Palo Verde Nuclear
Generating Station

102-04592-SAB/TNW/JAP
July 26, 2001

**Subject: Palo Verde Nuclear Generating Station (PVNGS)
Units 1, 2, and 3
Docket Nos. STN 50-528/529/530
Additional Information for the Addition of the
CENTS Computer Code to Section 5.0 of
Technical Specifications**

Additional Information for the Addition of the
CENTS Computer Code to Section 5.0 of
Technical Specifications

Figure 3
RCS Pressure vs. Time
CEA Ejection RCS Peak Pressure Analyses

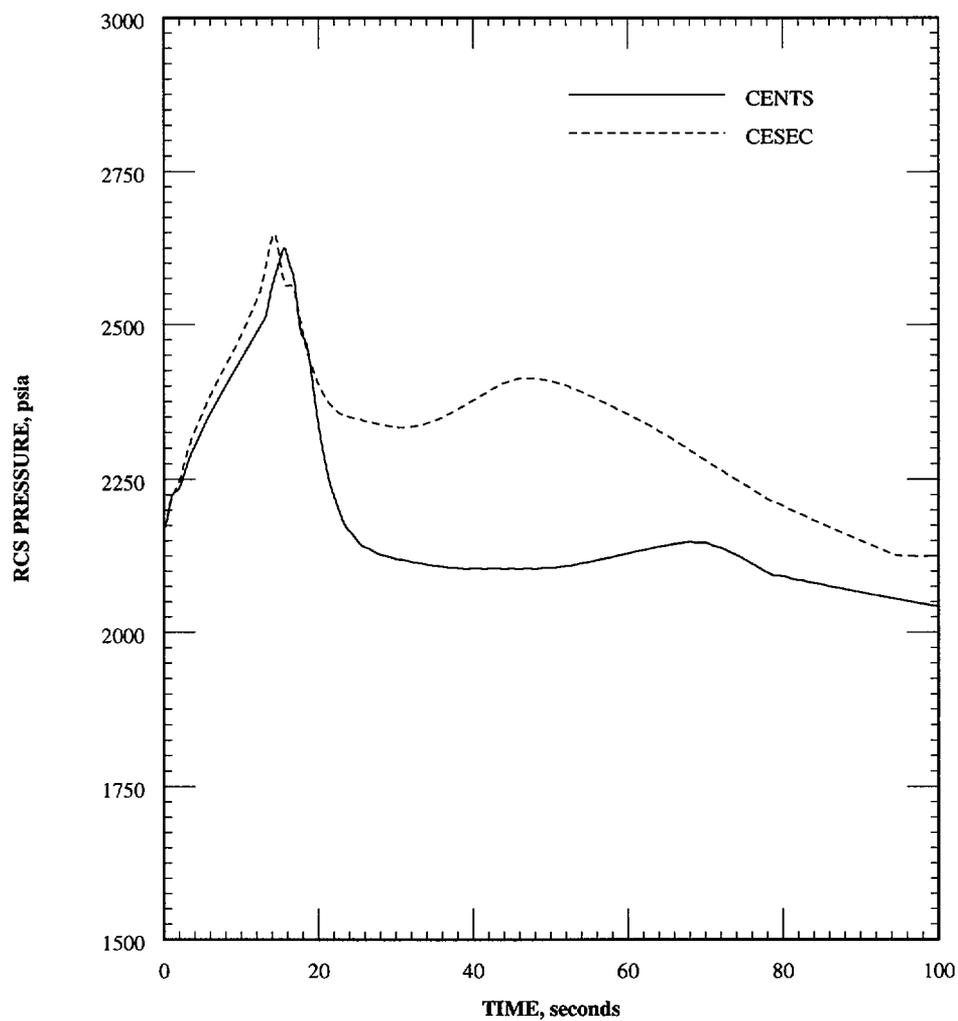
During the April 25, 2001 and May 29, 2001 phone calls between the PVNGS and NRC staff, some questions were raised regarding differences in the initial conditions between the CESEC and CENTS code Nuclear Steam Supply System (NSSS) response predictions in the benchmark study presented in Enclosure 3 of the Technical Specification submittal.

3.1 RCS Pressure after Reactor Trip (Figure 3): Between the time of maximum RCS pressure (~18 secs.) and 30 seconds, the CENTS predicted pressure drops below the CESEC predicted pressure. This is due to the different SG models in CESEC and CENTS. As explained in Reference 2, the CENTS steam generator model includes a separate downcomer node. This downcomer node explicitly contains subcooled water, and this relatively cold water provides a significant thermal inertia and heat sink after trip. In contrast, CESEC models the steam generator as a single node containing saturated water and steam. Because of this difference, CESEC predicts some RCS swell after trip, which results in higher RCS pressure. Some of the other important parameters in addition to RCS pressure are affected by the different SG models. For example, between 30 and 60 seconds, the RCS temperatures calculated by CENTS are colder than those calculated by CESEC.

To demonstrate the effect of this thermal inertia after the trip, the supplemental case is executed up to 100 seconds (the transient that was presented in Reference 1 ended at 60 seconds). After the termination of the feedwater flow, recirculation in the steam generators equalizes the temperatures in the downcomer and the evaporator/riser for the CENTS simulation resulting in a converging trend in the CENTS and CESEC predictions for RCS pressures and temperatures.

Figure 6
SG Pressure vs. Time
CEA Ejection RCS Peak Pressure Analyses

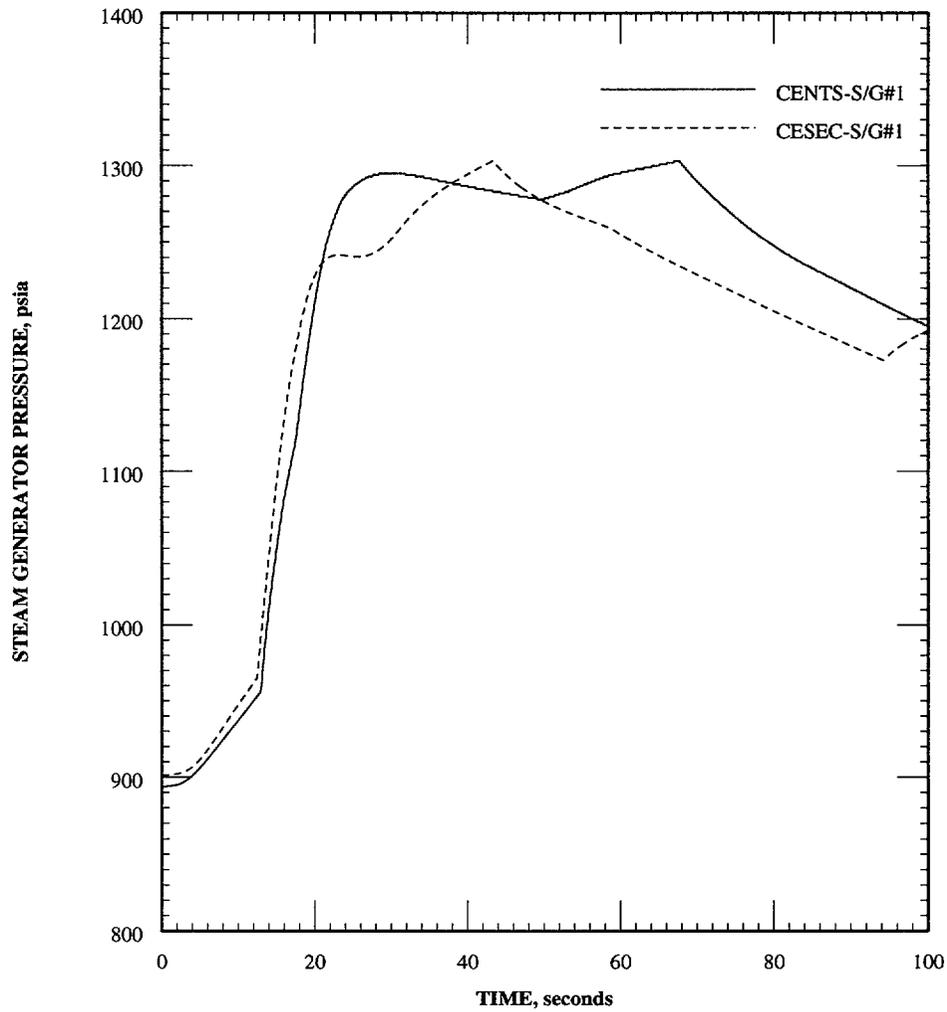
2.4 Initial Steam Generator Pressure: There was about 35 psi difference in initial steam generator pressures between the two codes (Figure 1.1.1-6 of the Enclosure 3 of Reference 1). This difference between the initial pressures was due to inconsistent specification of steam generator design parameters in the CESEC basedeck, and does not reflect an intrinsic difference between the two codes. The CESEC case in the supplemental study was tuned with inputs chosen so that the initial steam generator pressure was in good agreement with measured plant data and the CENTS basedeck (note that in the earlier study the CENTS basedeck was prepared based on the measured plant data while CESEC basedeck reflected predicted design values). With these changes, only a small difference (approximately 8 psi) remains between the initial SG pressures calculated by the two codes. The effect of the initial steam generator pressure on the peak RCS pressure is not significant (determined to be approximately 6 psi due to 35 psi initial pressure difference that was presented in Reference 1) for this event.

3.2 Steam Generator Pressure (Figure 6): After correcting the CESEC initial steam generator pressure and matching the feedwater flow input in both CESEC and CENTS cases, the plot presented in Figure 6 of this supplemental study shows a better comparison of both code's predictions. Two features of the CENTS code contribute to the difference in pressure predictions between the time of trip and the time of opening of MSSVs (~ at 1300 psia) namely, the detailed modeling of the main steam line header, and the effect of thermal inertia provided by the separate downcomer node. The first one provides a small addition to heat removal by the steam generators after the turbine admission valves are closed. CESEC does not model the pressure difference between the steam generators and turbine admission valves, while CENTS calculates additional steam flow out of the steam generators after the turbine admission valves are closed until the pressure in the main steam line header reaches equilibrium. This phenomenon can be seen in the integrated steam flow plot (Figure 9) and is the cause for the slight change in the rate of pressure increase between the time of trip and approximately 20 seconds in CENTS steam generator pressure. The second feature was explained in 3.1 above, and results in the difference in steam generator pressure responses.

The difference in steam generator pressure trend around 90 seconds is caused by closure of the MSSVs in CESEC. While not shown in Figure 9, MSSV closure occurs shortly after 100 seconds in CENTS.
